City of Portland  
Bureau of Development Services

# Land Use Review Appeal to **City Council**

LU 14-117884 DZM

**Block 37 - South Waterfront**

# Modification - Setback Along SW Lane

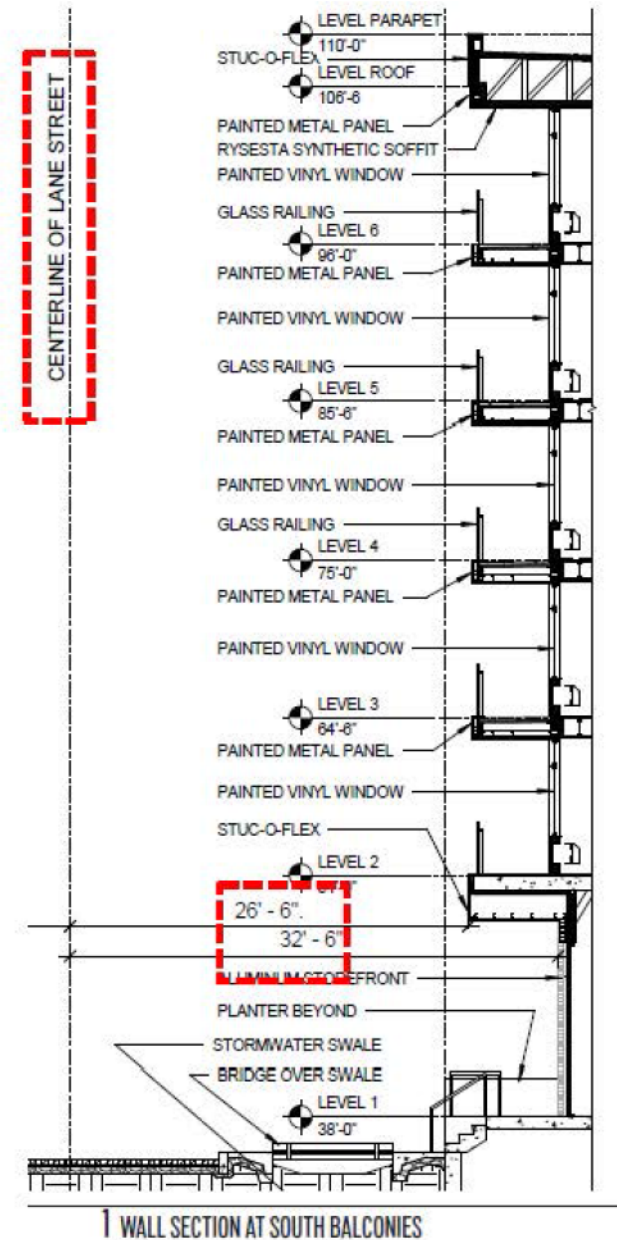
Appellant states Modification approval criteria has not been met thus approved in error.

Appellant – projection into Lane does not meet Accessway purpose to provide a visual connection to Greenway & a transition from the natural Greenway to the urban development.

- Additional findings stated that support building projection Modification:
    - 60' accessway width based on potential for tower development.
    - Width (similar to typical Central City block structure) is sufficient for tall buildings (ratio of open space, natural light and air to built space).

- Smaller scale of proposed building, accessway width is more than adequate and could accommodate a 3'-6" projection.
